STAFF REPORT

SUBJECT: Avani Neighborhood AZ, PP
H-2023-0049

Annexation of 35.086 acres of land to the R-15 (Medium-high-density residential) zoning district; and Preliminary Plat consisting of 256 building lots and 25 common lots on 33.71-acres of land in the R-15 zoning district for Avani Neighborhood Subdivision.

NOTE: Staff is recommending denial of the project because the applicant’s design (plat and elevations) is inconsistent with the design elements outlined in the TMISAP. The applicant has been made aware of Staff’s concerns and has elected to forego some of Staff’s recommended changes to gain a favorable recommendation. Below provides the basis for Staff’s recommendation; however, the Commission and Council should rely on all relevant information when determining if this project is consistent with the Plan and open to allowing deviations from the design elements as desired by the Applicant.

D. Common Drive Exhibit – *NOT APPROVED*

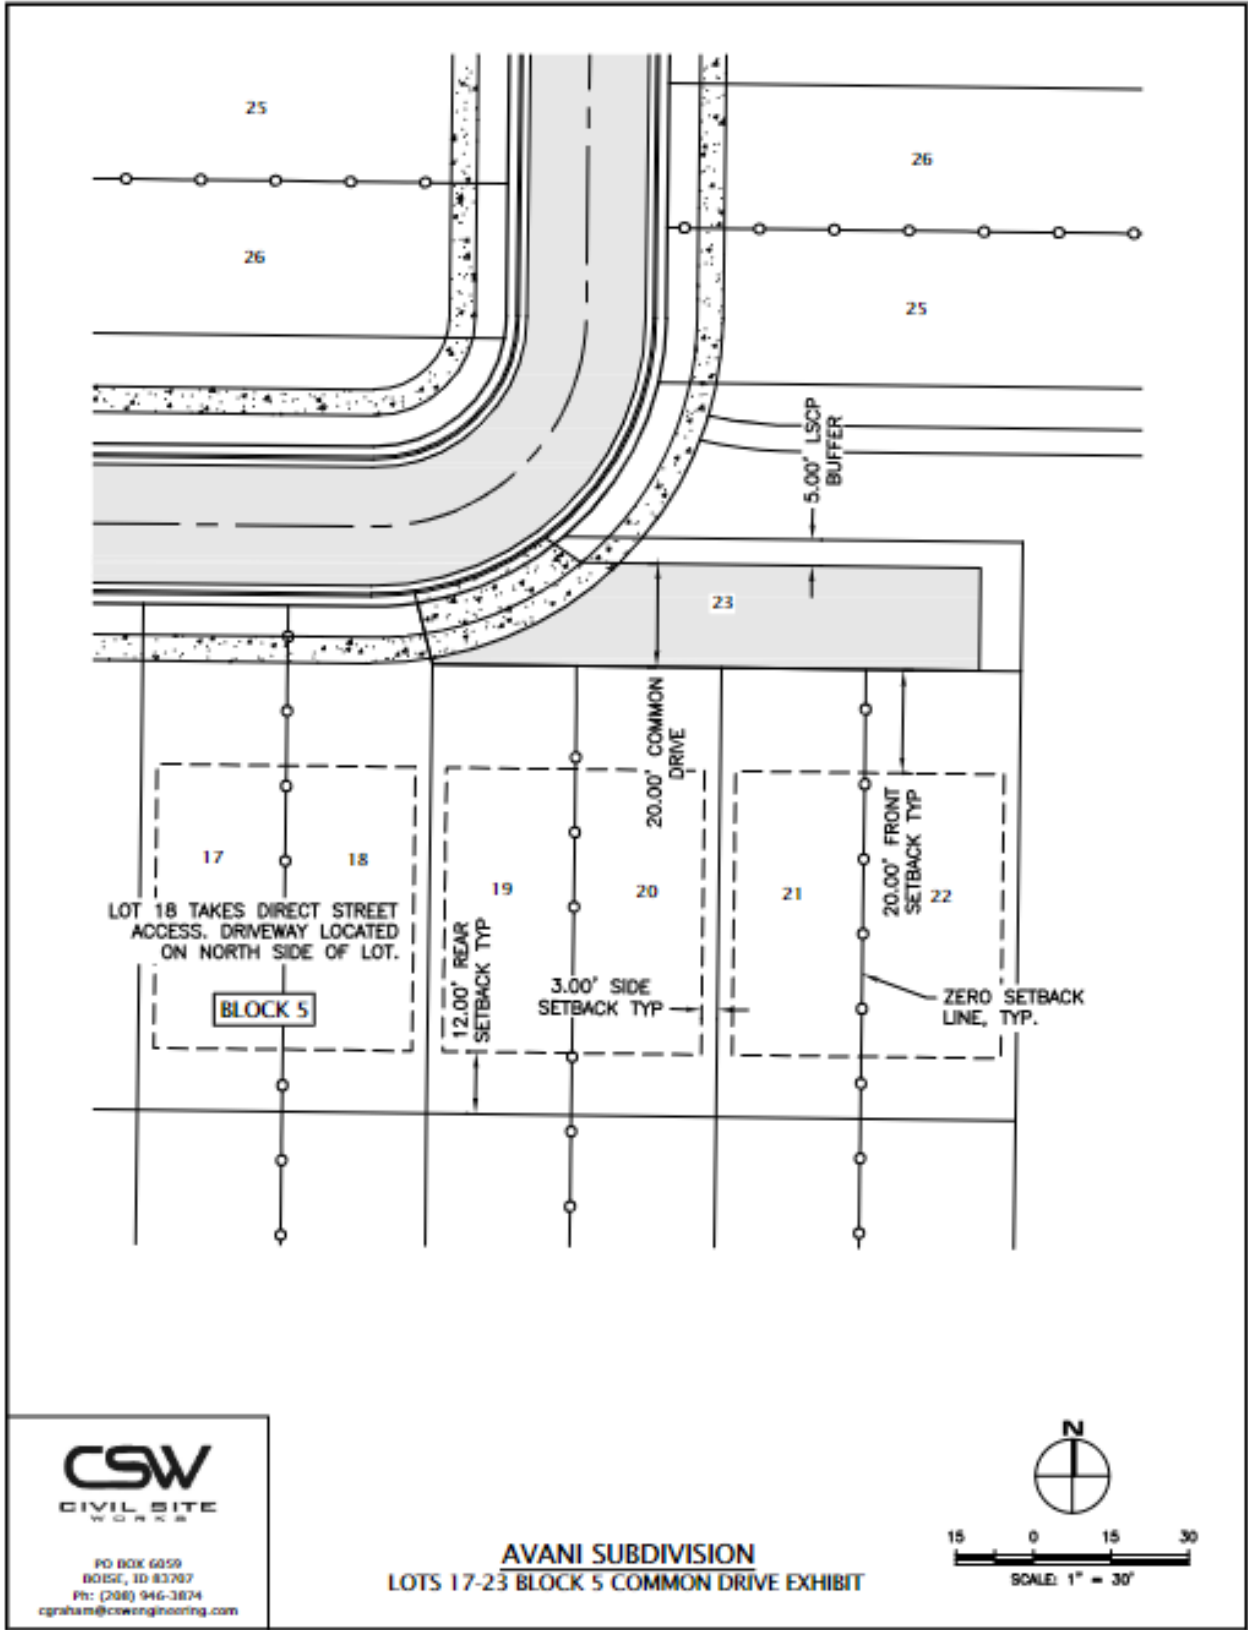
Local streets, alleys, and common drives are proposed internally for access to the proposed residential units. **Staff believes the plat should incorporate more ally-loaded lots however, the Applicant believes there isn’t a market for this type of housing and has elected to limit the number of alley-loaded homes to ten (10) which is inconsistent with the Plan.**

The proposed residential use and mix of housing types may be consistent with the MHDR FLUM designation; **however, the proposed density of 7.59 is below the target density of 12 dwelling units per acre. The proposed architectural design does not comply with the TND guidelines in the TMISAP, as discussed above. Development in this area should conform to these guidelines in order to be deemed consistent with the Plan and determine if it is in the City’s best interest to annex this property.**

The Applicant is proposing one (1) curb cut-off of Vantage Point Way, a planned collector street in the TMISAP. In accordance with UDC 11-3A-3 (Access to streets), multiple accesses off an arterial and/or collector roadway shall be restricted. The Applicant has proposed an emergency access only off of Black Cat Road and has included a stub street to the north (Street H) for potential future access. **Staff recommends that the Applicant collaborates with the property owner to the east to consider incorporating a potential stub street on the east side of this site for connectivity to the future Medium-High Density Residential Development, subject to approval by ACHD.**

Common Driveway (UDC [11-6C-3D](#)): Six (6) common driveways are proposed within the development of the site on Lot 42, Block 1, Lot 16, Block 1, Lot 41, Block 2, Lot 33, Block 2, Lot 16, Block, 2, and Lot 23, Block 5. Common driveways are allowed to serve a maximum of four (4) dwelling units; in no case shall more than three (3) dwelling units be located on one (1) side of the driveway. **A total of four (4) dwelling units are proposed on the south side of driveway for Lot 23, Block 5; the final plat and common driveway exhibit shall be revised to depict a maximum of three (3) units on one (1) side of the driveway as required; or, alternative compliance may be requested as set forth in UDC [11-5B-5](#).**

to comply with this requirement. Additionally, the common driveway located at the southwest corner of the development should incorporate a sidewalk adjacent to the 5-foot landscape buffer connecting to the 10-foot wide pathway along S. Black Cat Road to enhance walkability within the neighborhood.
